NORTHERN BEACHES LOCAL PLANNING PANEL

WEDNESDAY 21 APRIL 2021

ITEM 3.1	DA2020/1453 - 1 ALEXANDER STREET & 4 COLLAROY STREET, COLLAROY - DEMOLITION WORKS AND CONSTRUCTION OF A SHOP-TOP HOUSING DEVELOPMENT
AUTHORISING MANAGER	Lashta Haidari
TRIM FILE REF	2021/261338
ATTACHMENTS	1 Assessment Report 2 Site Plan & Elevations 3 Clause 4.6

Figure 1: Height breach diagram (south elevation)

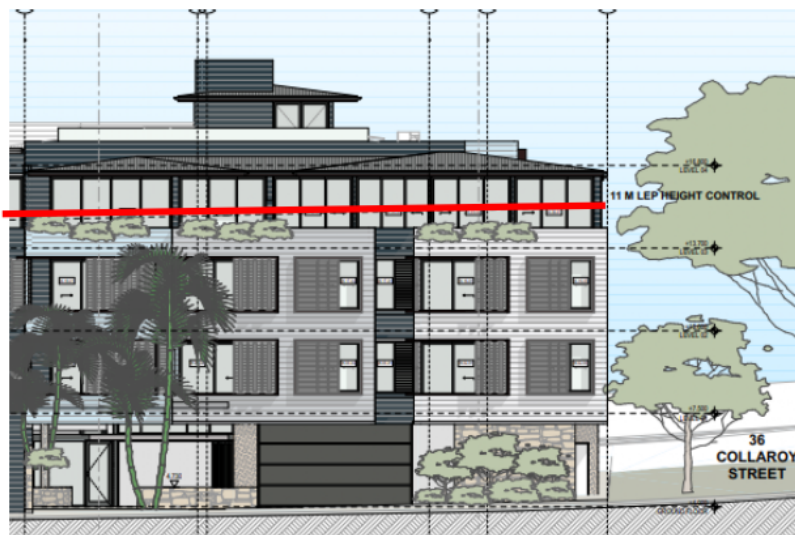
The Collaroy Street facing building has a maximum height of 12.2 metres measured at its leading gutter line with the roof terrace balustrade and lift overruns/ stair cores beyond extending to maximum heights of 14, 16 and 17 metres respectively representing variations of 3 metres (27%), 5 metres (45%) and 6 metres (54%) respectively. The building height breaching elements are depicted on the architectural plans extracts of which are at Figures 1, 2 and 3 below and over page.

Image 2 - Dwelling footprint

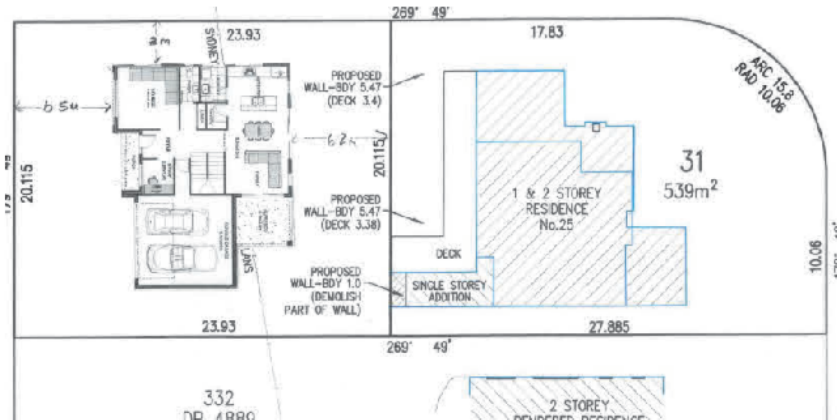
Clause 4.1.1.2 requires a subdivision involving a new lot for residential development less than 600sqm must identify on the subdivision plan that a dwelling can be successfully accommodated on each allotment, in compliance with this Plan.

The dwelling footprint lodged with the application (see image below) is inadequate and does not illustrate that a dwelling can be successfully accommodated on site.

Figure 2: Building Height non-compliance on the north-west elevation shown in green.

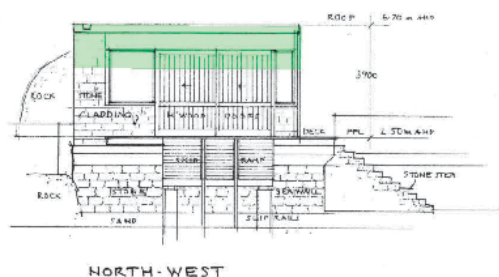
The proposal seeks a maximum building height of 5.53m, thereby contravening the development standard by 38.25%, see Figure 2 & 3 below.
